BOROUGH OF
SPRING LAKE HEIGHTS, N.J.

ZONING PERMIT

Project
New Residence For:
Nicholas and Emily Bilotti
585 Monmouth Avenue,
Spring Lake Heights, NJ
Block 76 Lot 7

Zoning Data and Site Plan

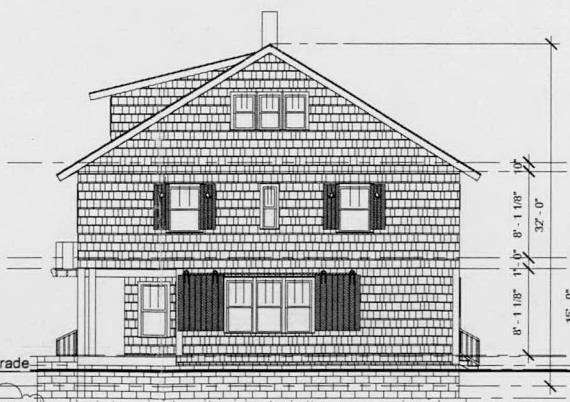
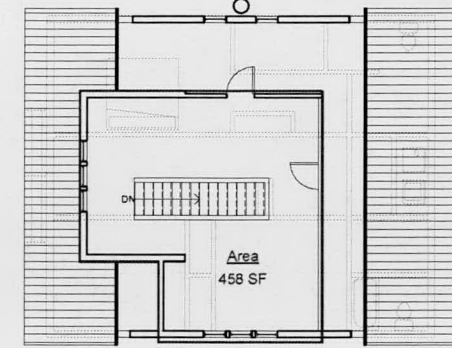
Please review the attached information and submit a revised Proposed site plan addressing the following items:

- Revised driveway, include apron and details of same
- Show sidewalk (all cracked or damaged sidewalk must be replaced)
- Proposed Grading Plan
- Proposed utilities and details of same
- Stormwater Management plan - (recharge piping is typically proposed – 1-1/4" /SF of roof area) not including Void in Stone

Properties must not allow water runoff to adjacent sites this must be incorporated into a proposed site plan

calculations must be provided for the storm water management. I would recommend that you contact an engineer to assist you.

Mr. May, attached is a revised site/plot plan sheet A101. Please substitute this with the previous sheet sent on December 19th. I missed adjusting the building height using the Top of Curb Vs. the Crown of Road as you directed. The house has be dropped approximately .28"+ that brings it into compliance. The 5 items identified in the previous email still apply.

- 1) Revised Driveway, including apron
- 2) Sidewalk shown (there are cracked areas on apron and adjacent walk) replacement is noted.
- 3) Spot grading shown, existing and proposed very little change.
- 4) Utilities locations are shown per field mark-out.
- 5) Storm water management shown.

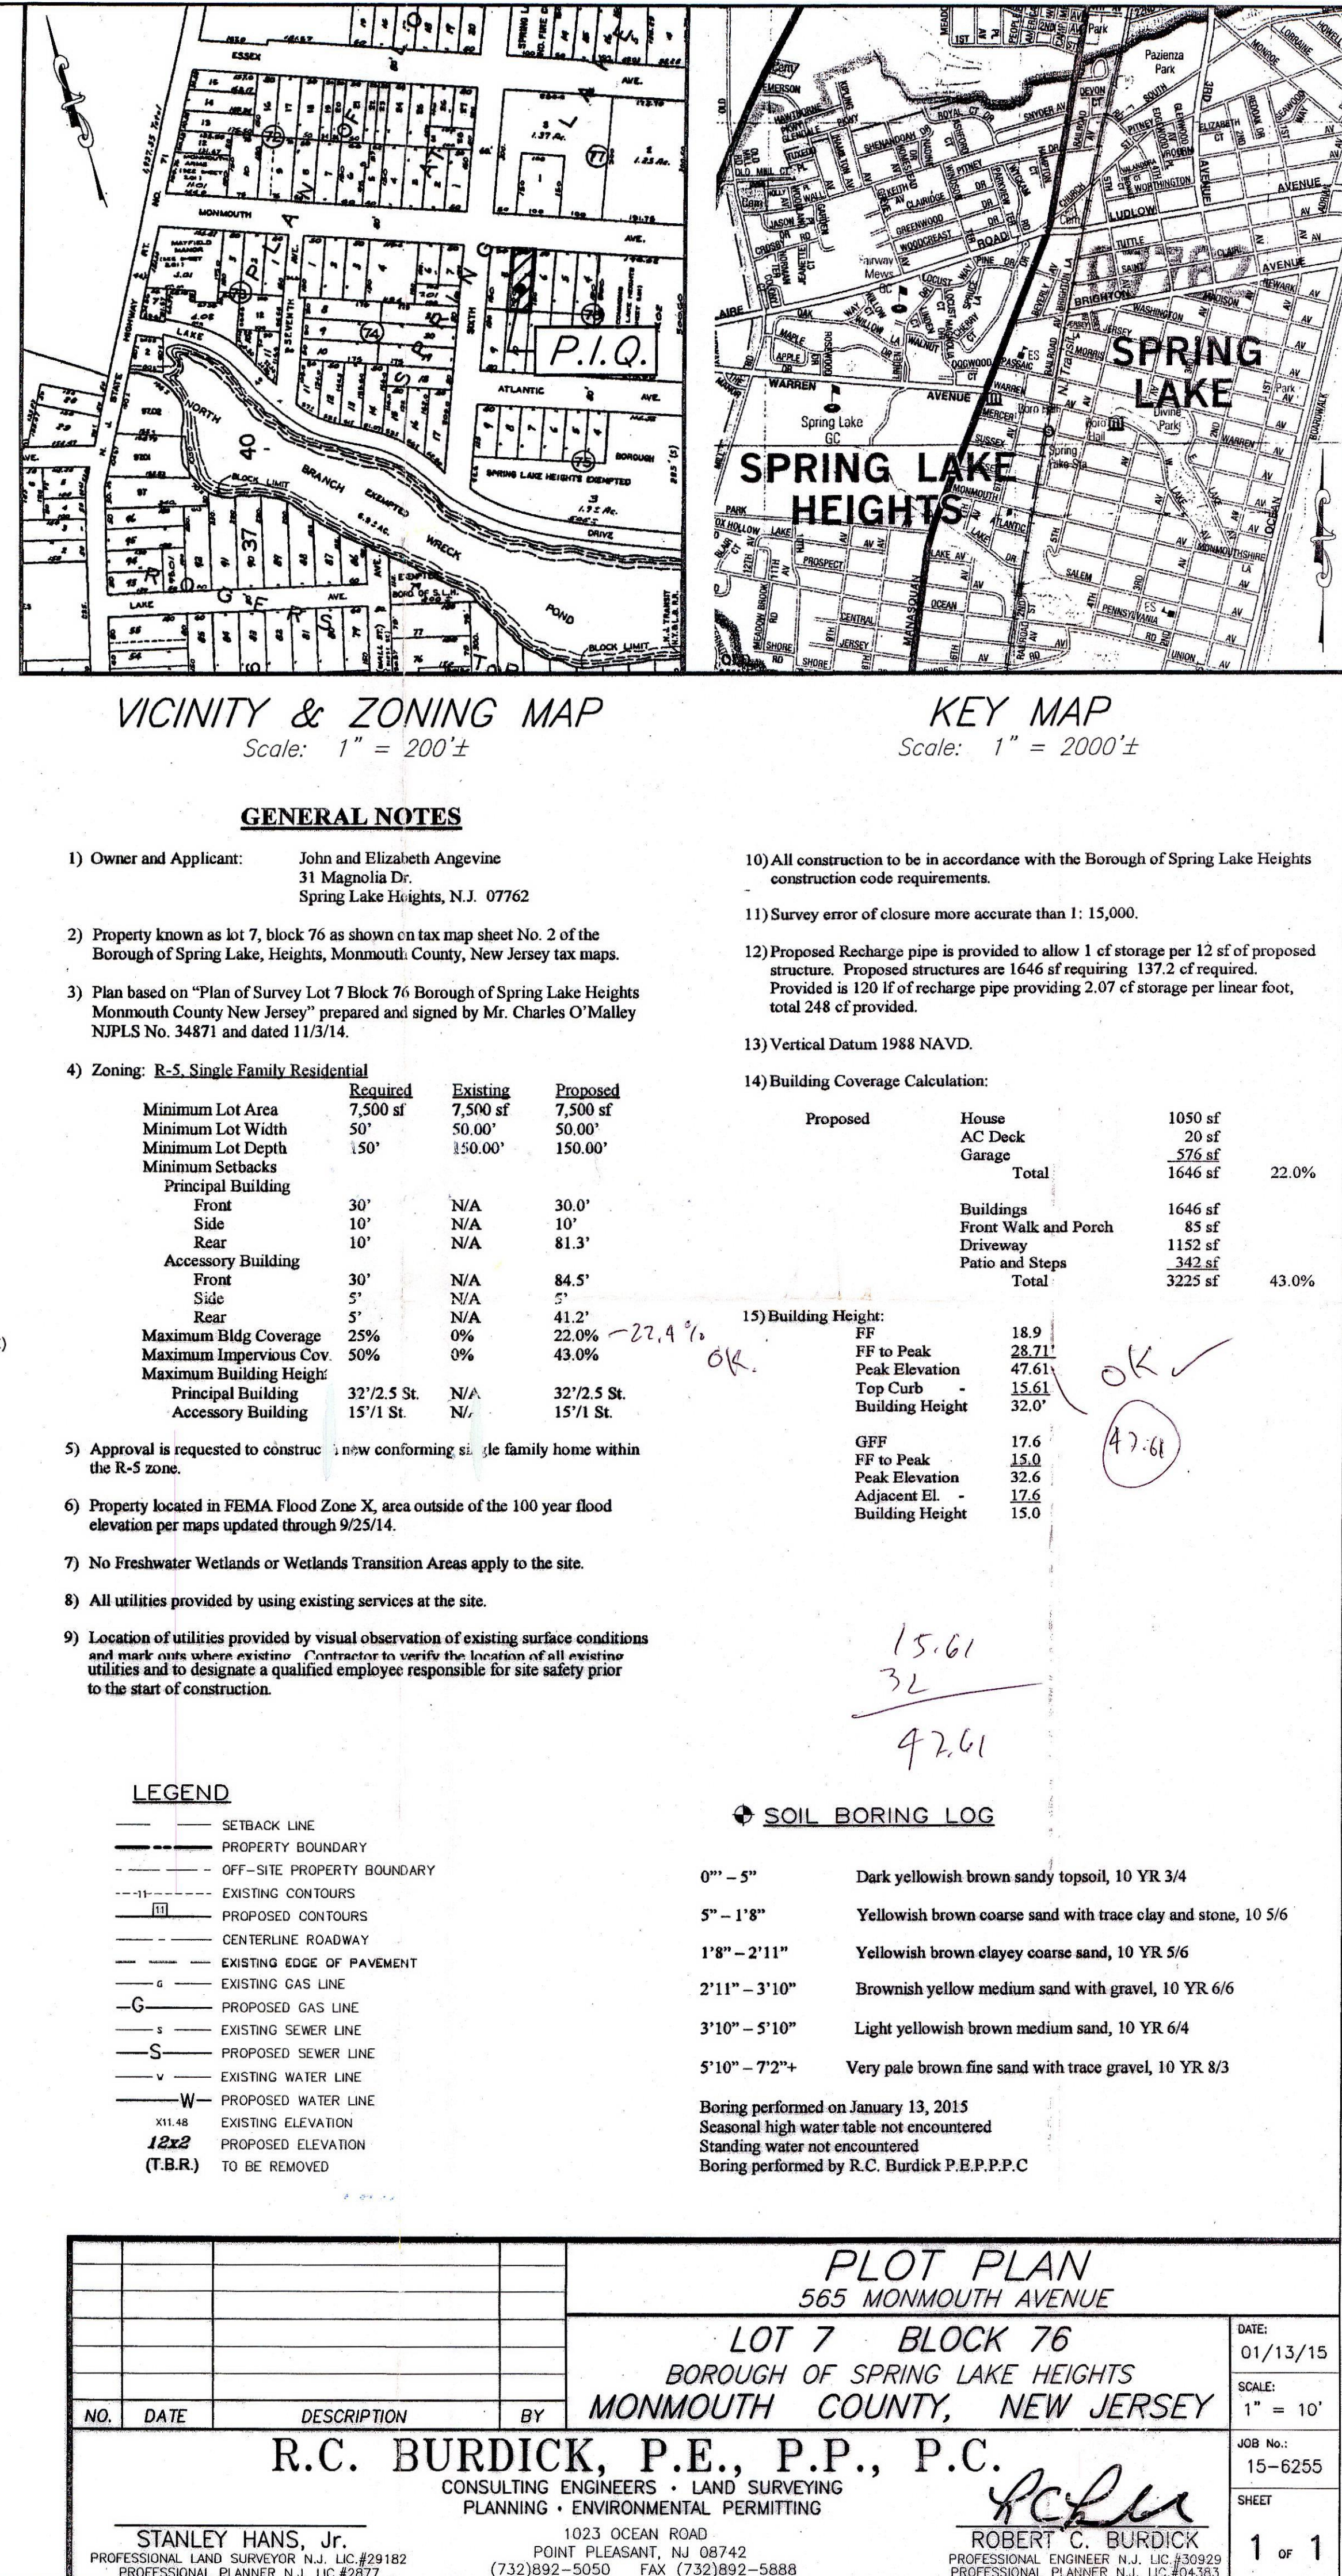
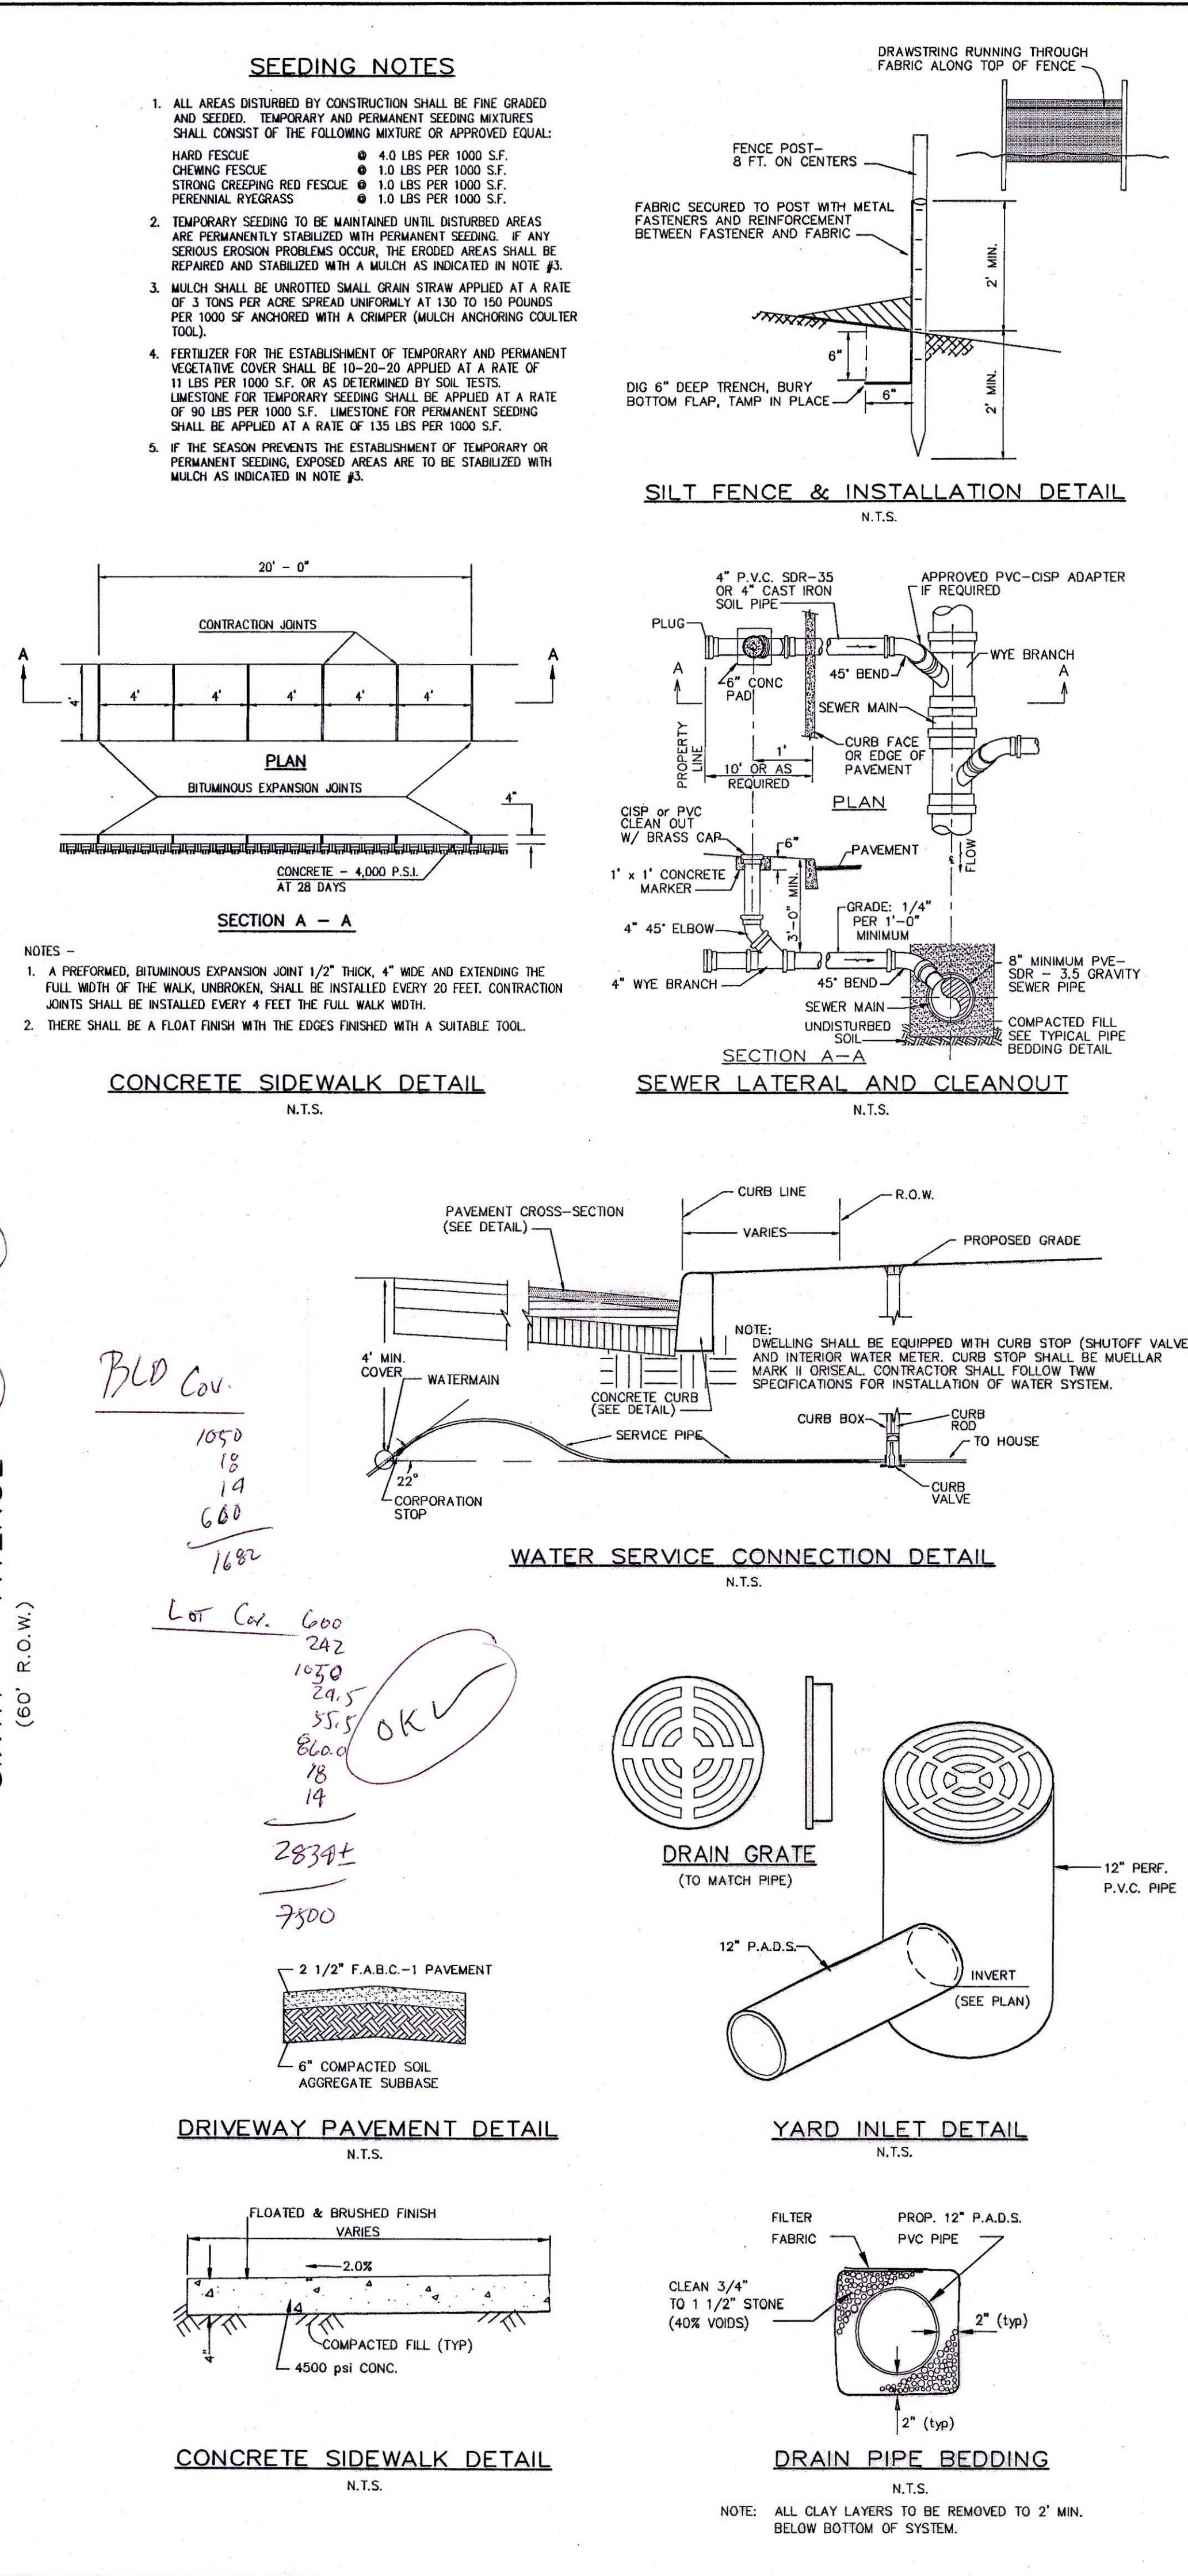
Brielle 4@verizon.net
NEED
info
not
ACCEPTABLE
12/29/14

- All construction to be in accordance with the Borough of Spring Lake Heights construction code requirements.
- Survey error of closure more accurate than 1: 15,000.
- Proposed Recharge pipe is provided to allow 1 cf of storage per 12 sf of proposed structure. Proposed structures are 1646 sf requiring 137.2 cf of required. Provided is 120 lf of recharge pipe providing 2.07 cf of storage per linear foot, total 248 cf provided.
- Vertical Datum 1988 NAVD.
